Mechanical Addendum M-001

Date: June 19, 2026
Project: Ontario Aboriginal Housing Services
Location: 321 John Street, Cobourg, Ontario
IVES Project: 22071

M-303A

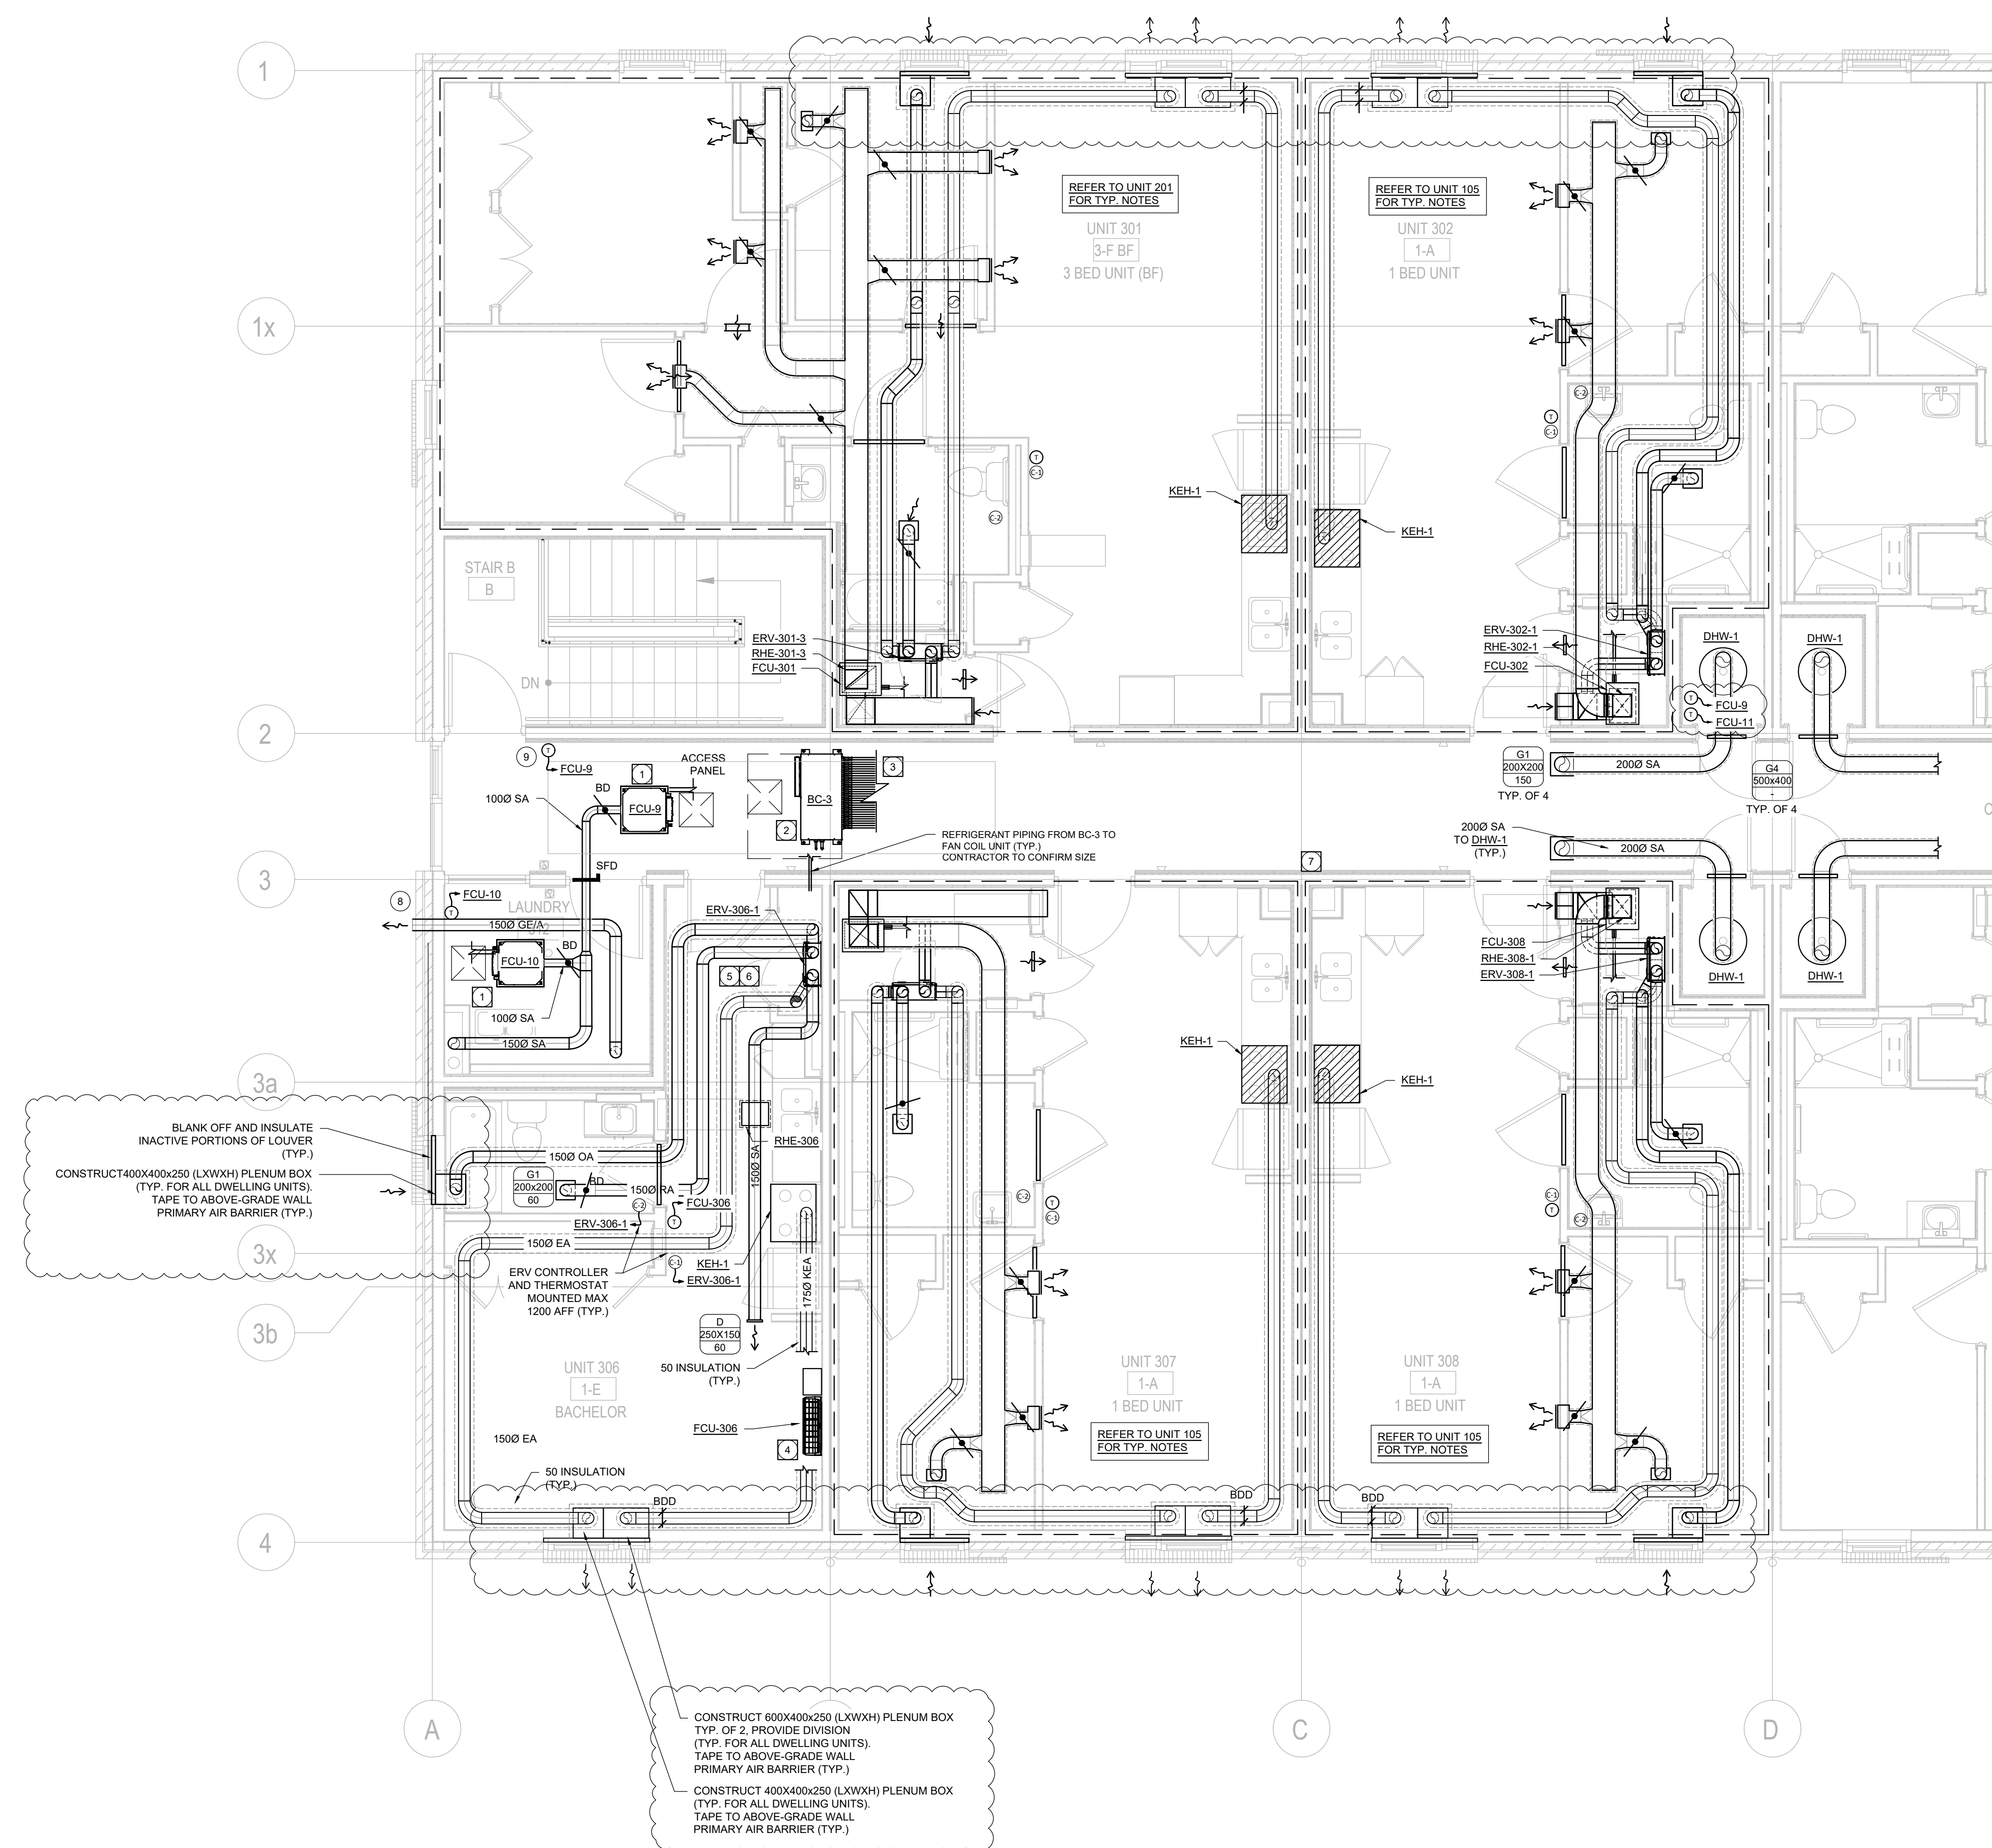
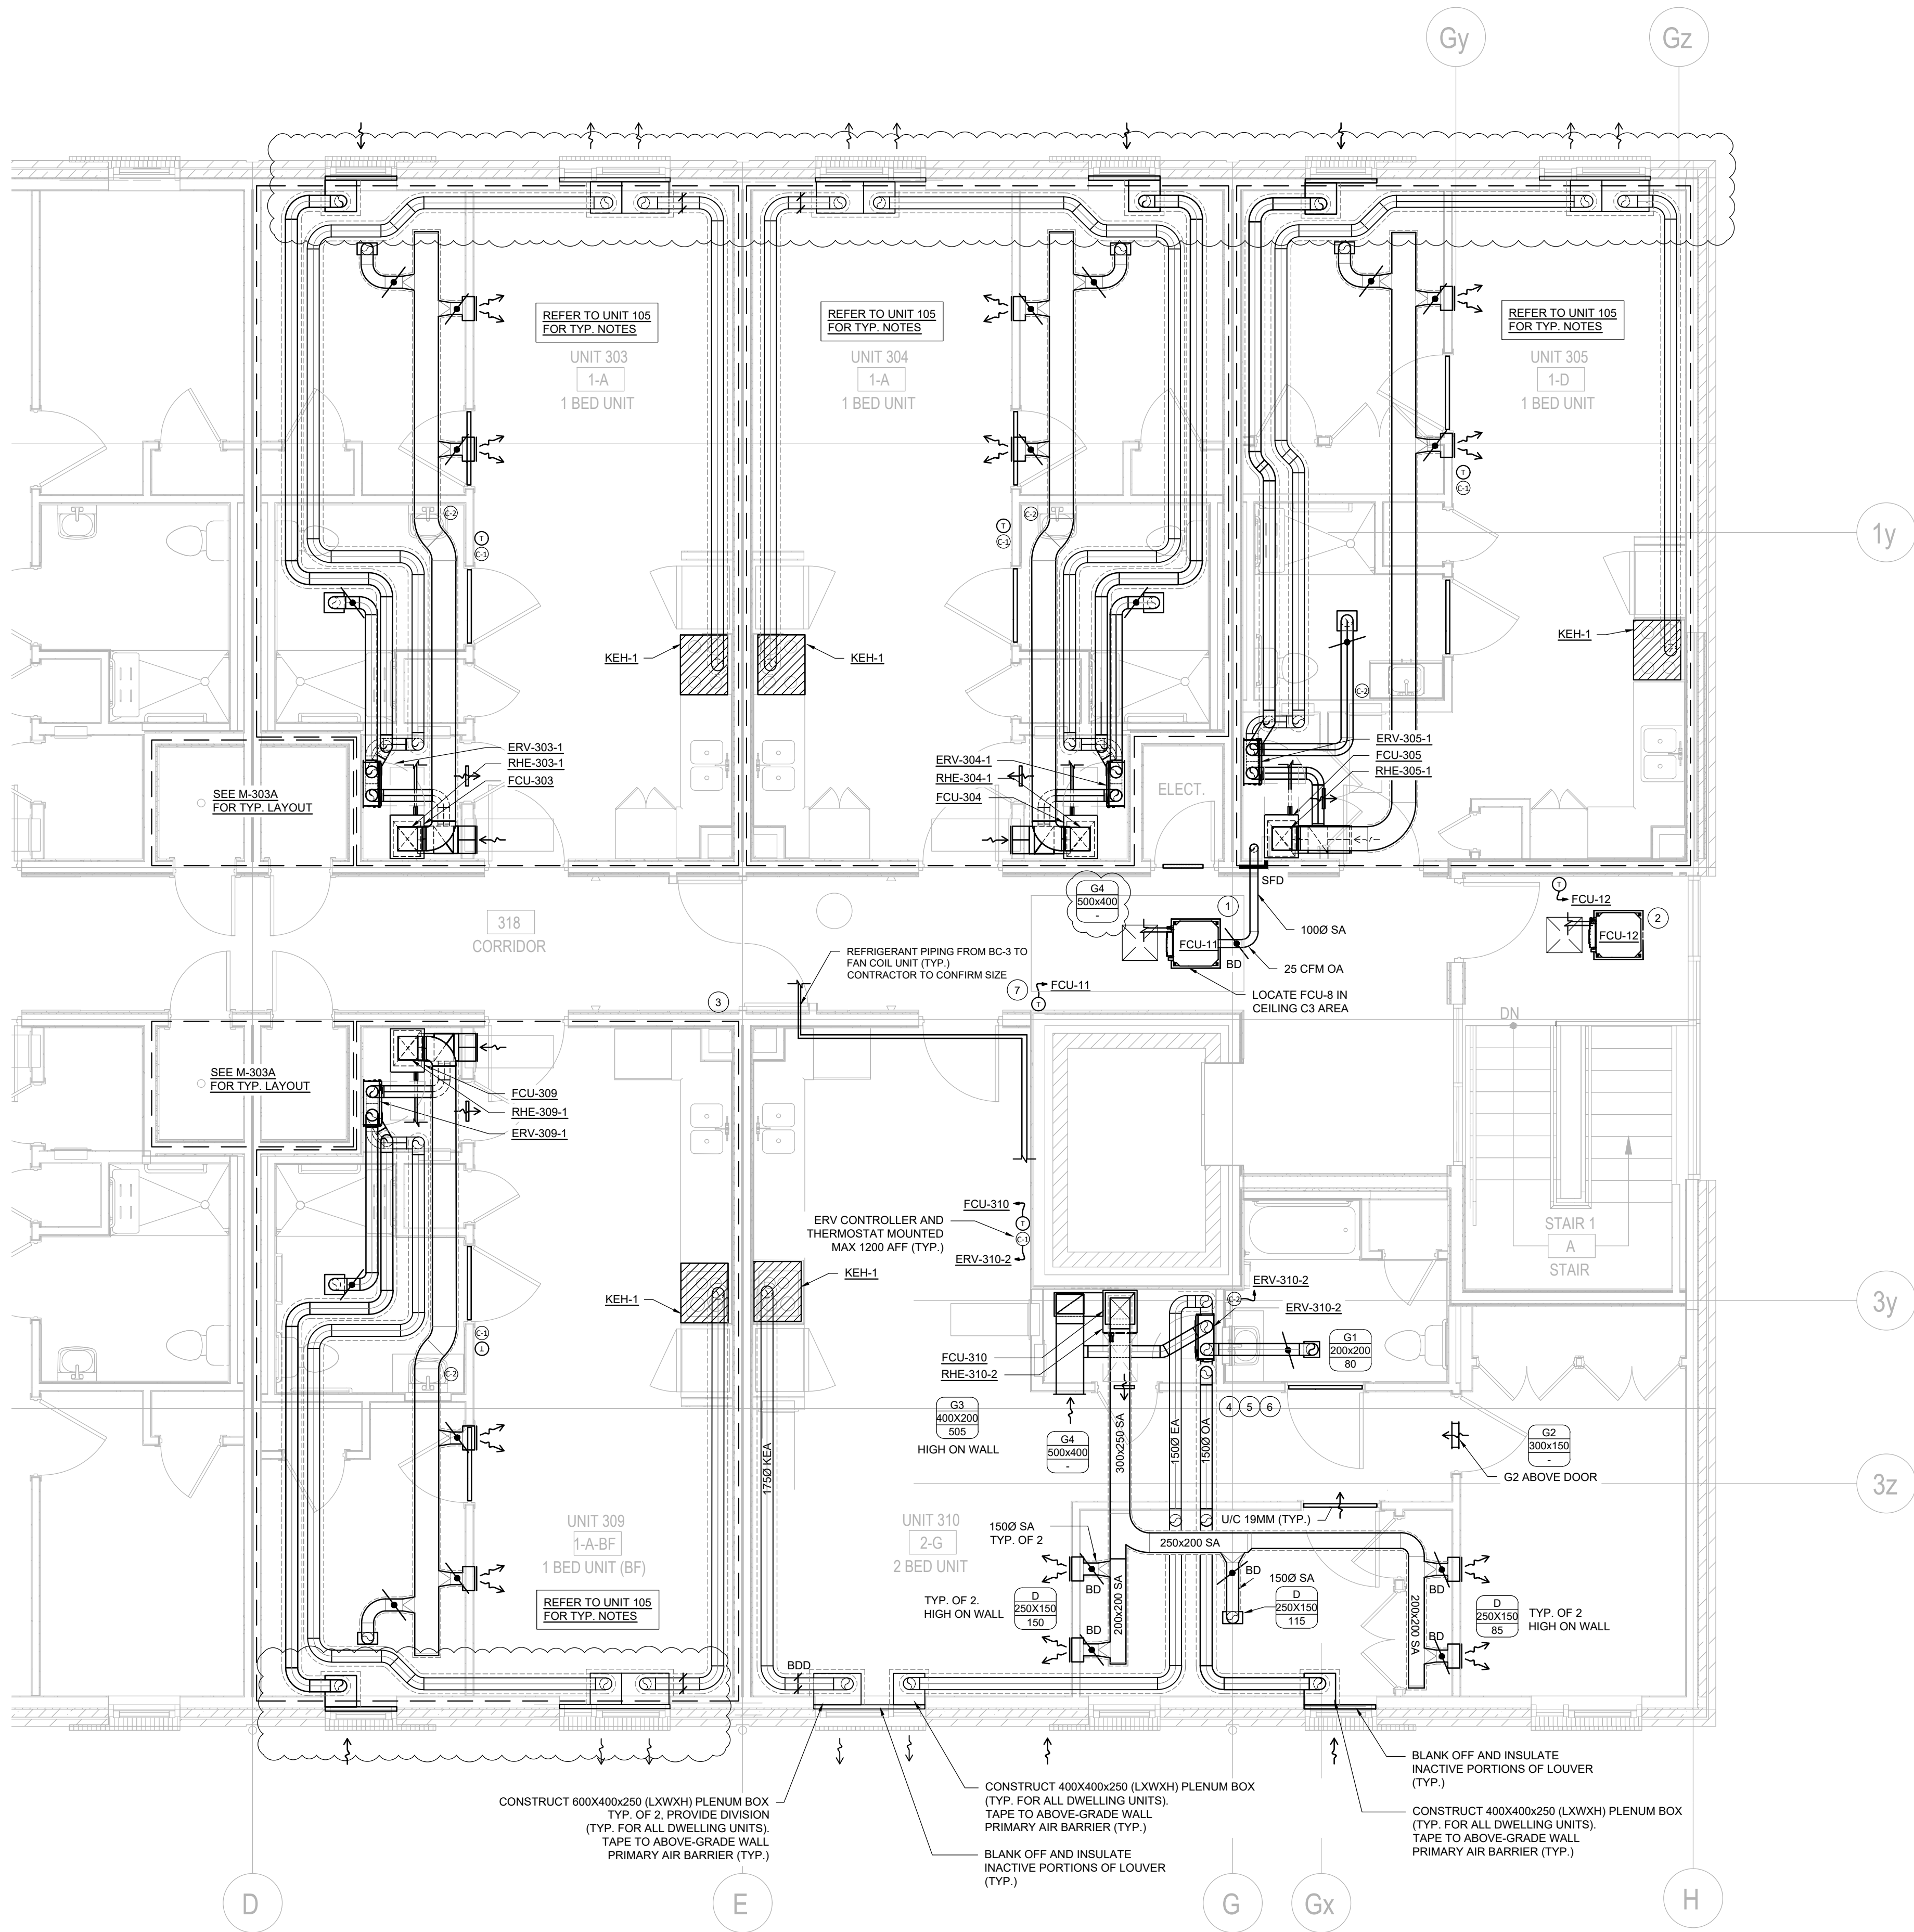
- 1.13.1. Revised as indicated.
- 1.14. Refer to Mechanical Drawing M-303A – Third Floor West HVAC Plan (Re-issued)
 - 1.14.1. Revised as indicated.
- 1.15. Refer to Mechanical Drawing M-303B – Second Floor East HVAC Plan (Re-issued)

- 1.15.1. Revised as indicated.
- 1.16. Refer to Mechanical Drawing M-400A – Underslab West Plumbing Plan (Re-issued)
 - 1.16.1. Revised as indicated.
- 1.17. Refer to Mechanical Drawing M-400B – Underslab East Plumbing Plan (Re-issued)

DRAWING NUMBER:
M-400B

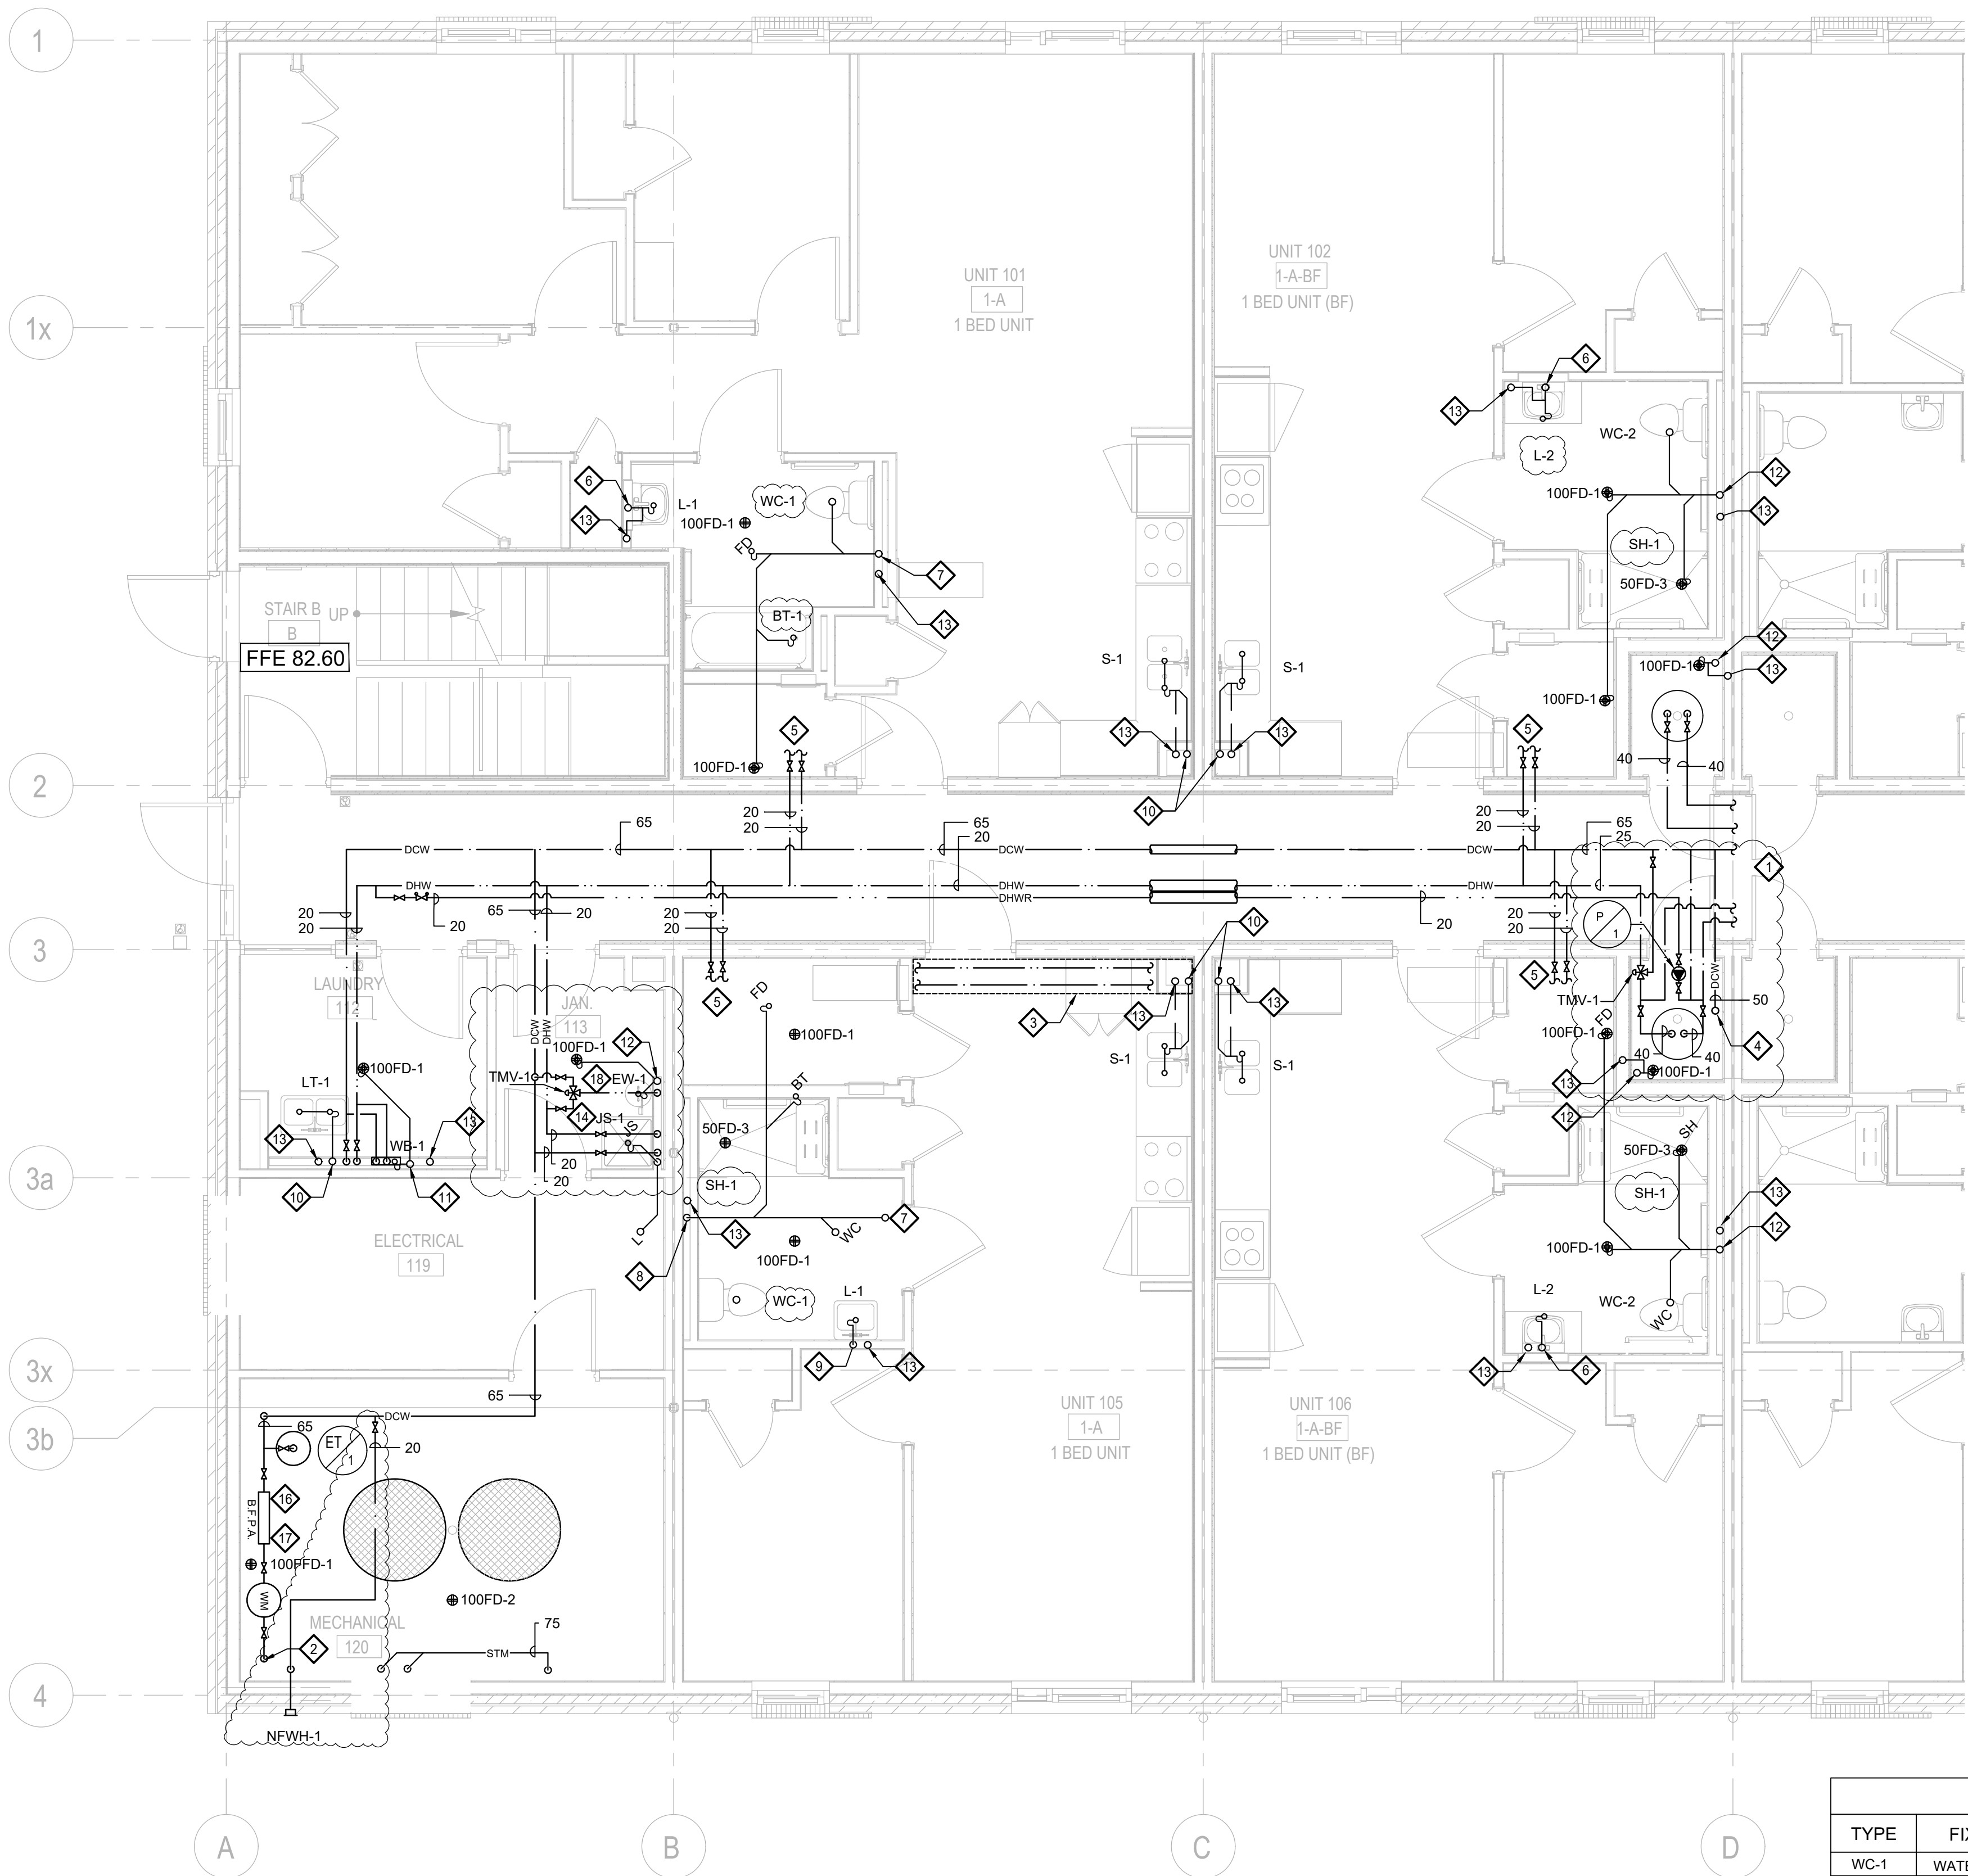
- 1.17.1. Revised as indicated.
- 1.18. Refer to Mechanical Drawing M-401A – Ground Floor West Plumbing Plan (Re-issued)
 - 1.18.1. Revised as indicated.
